Subject: September 2010 Inspection Report, Cameco Resources, Permits 603 & 633

**SEPTEMBER 2010 INSPECTION REPORT
DISTRICT 1/LAND QUALITY DIVISION**

COMPANY: Cameco Resources (CR), Highland Ranch, Permit #603
& Smith Ranch, Permit 633

Figure 3 Reclaimed slope above channel that should be monitored for erosional rilling

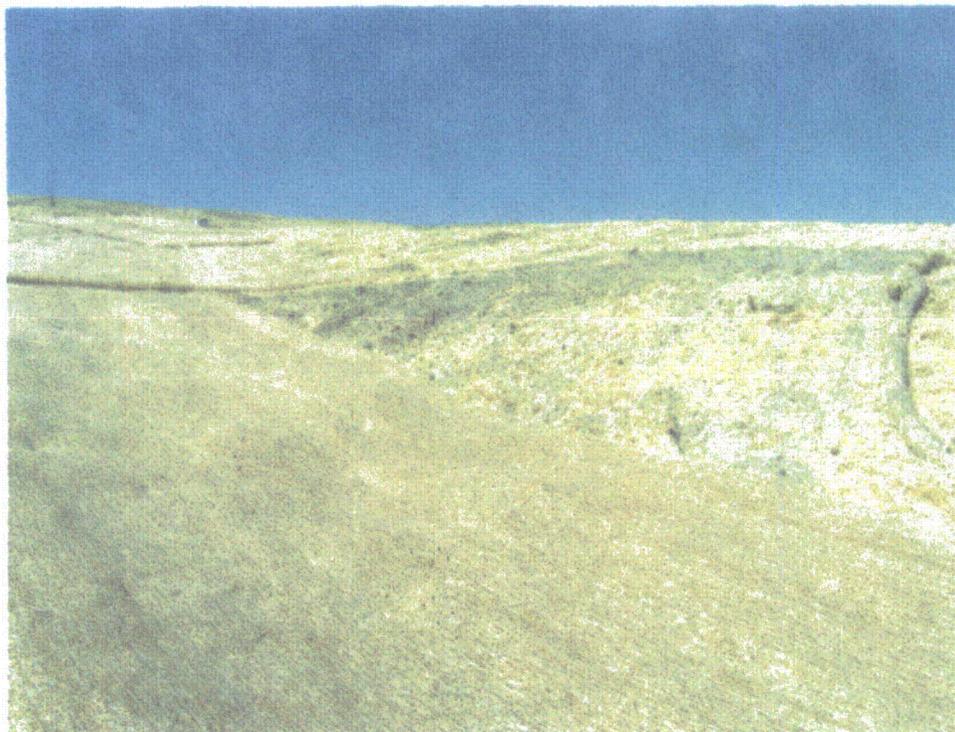
The reclamation appeared adequate. An area of the slope break from the top of the reclaimed pad should be monitored for erosion where there is limited mulch/fabric protection (Figure 3). There is potential for rilling which could undercut the fabric below.

- 1 The reclaimed slopes at DDW#6 should be monitored for rill development which could undercut the erosion control fabric. The reclamation appears adequate; however, until vegetation is re-established, the slopes are not stable.
- 2 The re-vegetation in Mine Unit 9 has not been successful. LQD understands that CR is developing a plan to revegetate. LQD encourages the effort to complete the temporary reclamation of this wellfield. According to Noncoal Rules and Regulations, Chapter 3,

Figure 4 Biomats installed in MU9 drainage

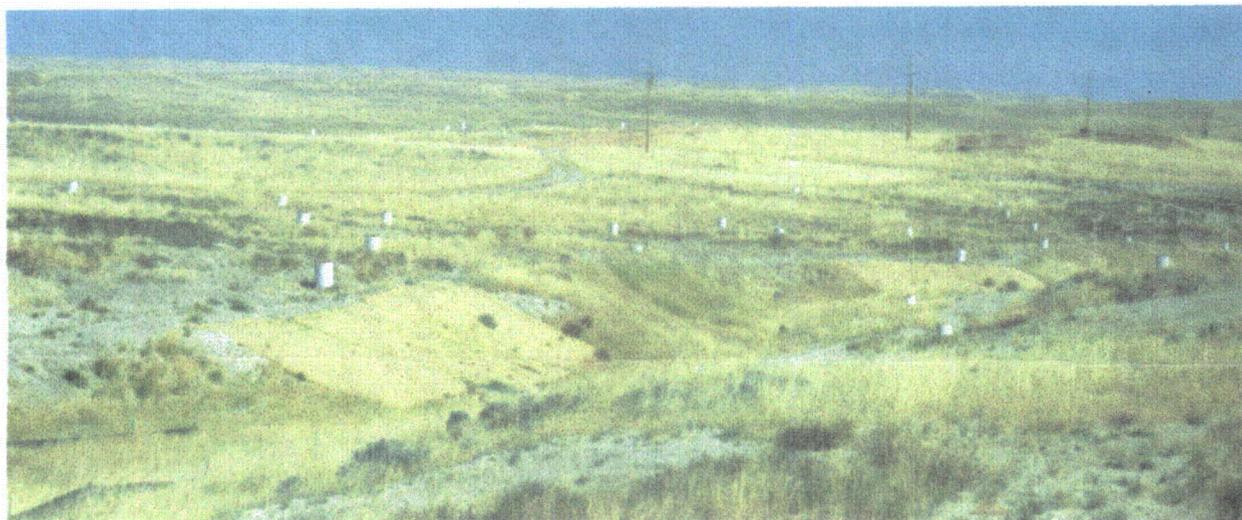
The ephemeral drainage through MU-9 was examined for slope stability. LQD inspectors had previously identified potential for erosion on the slopes following the apparent unsuccessful revegetation. CR has used biomats in locations along the drainage to provide stability and to help revegetate the slopes (Figure 4). The re-vegetation was not obviously successful since the installation of the biomats, however, no further erosion was noted on the slopes. The northeast end of the MU-9 reclamation was noted to be unsuccessful. CR is evaluating their seeding methods used for this area and developing a plan for re-application of seed. Noxious weeds were not noted in the reclamation. The south end of the wellfield had new mulch installed but it did not appear crimped into the soil.
